**HUDSON RIVER PCBs REASSESSMENT RI/FS
RESPONSIVENESS SUMMARY FOR
VOLUME 2A: DATABASE REPORT
VOLUME 2B: PRELIMINARY MODEL CALIBRATION REPORT
VOLUME 2C: DATA EVALUATION AND INTERPRETATION REPORT**

DECEMBER 1998

**U.S. Environmental Protection Agency
Region II
and
U.S. Army Corps of Engineers
Kansas City District**

**TAMS Consultants, Inc.
Limno-Tech, Inc.
TetraTech, Inc.
Menzie-Cura & Associates, Inc.**

Figure E-4. Log K_{oc} of BZ#27 as a function of inverse temperature. Only Transect studies 1-6 from the Thompson Island Dam to Waterford: Left, with temperature correction; Right, without temperature correction.

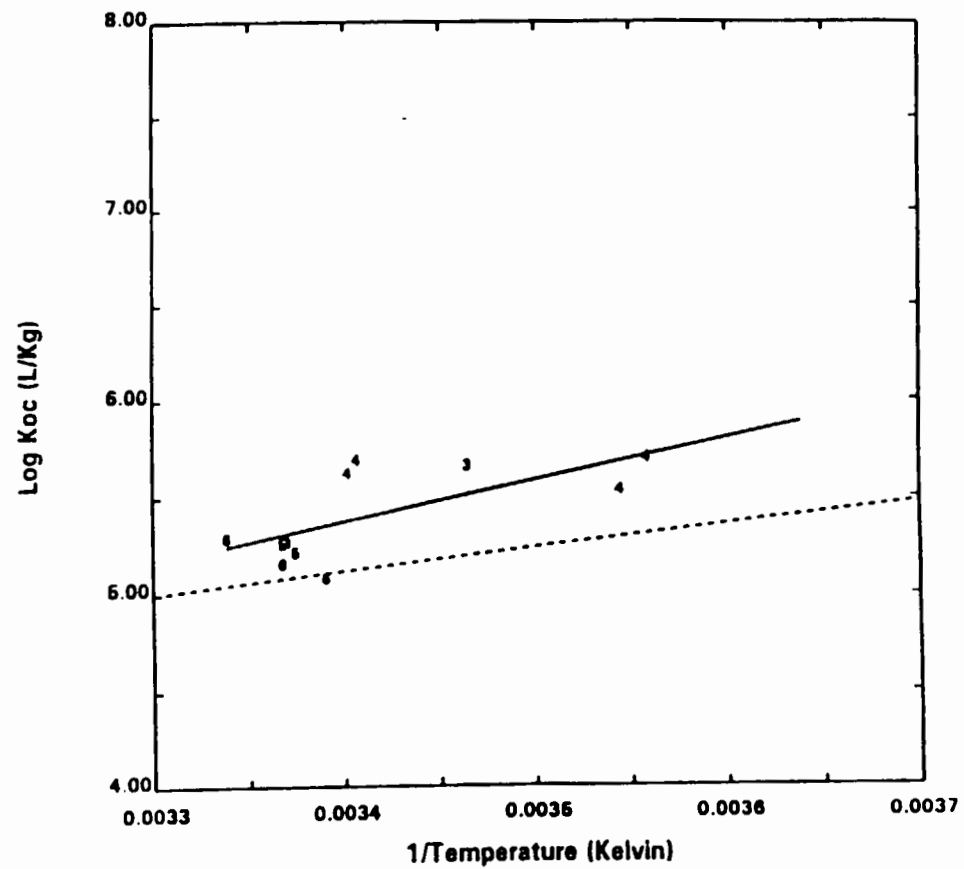
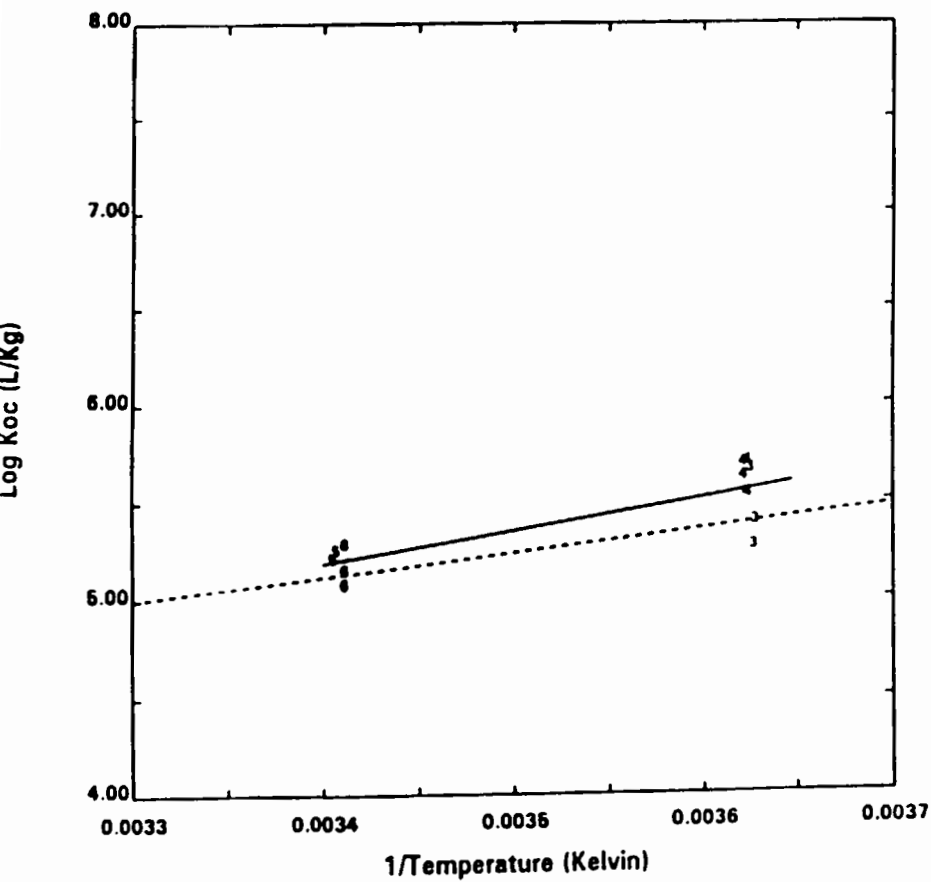
The analysis of the temperature dependence of partition coefficients (p 3-16) is based upon historical data reported in Warren, et al (1987). It is not clear why this data was used to determine the temperature dependence of partition coefficients when the Phase 2 data collected covers a sufficient range in temperature to determine temperature dependence directly. Figures E-3 and E-4 show $\log K_{oc}$ vs $1/T$ for congeners 10 and 27.

It should be noted that these values of temperature have been corrected to ambient river temperature. Figures E-3b and E-4b show $\log K_{oc}$ vs $1/T$ for congeners 10 and 27 based on the temperature reported in the Phase 2 data. That this temperature is not ambient is evident by the large temperature differences within transects as well as the reporting of high (~20 degC) temperatures in the early Spring surveys. Figure E-5 shows a comparison of ambient TI Dam water temperature data collected by OBG as compared to those reported in the Phase 2 transect data. In all transects the reported Phase 2 temperature is higher than ambient. It is not clear when and where the Phase 2 temperatures were taken, especially in relation to the time of filtration of water samples. If the filtration was performed before samples reached equilibrium at the higher temperatures, values of $K_{oc}(20)$ will be biased high.
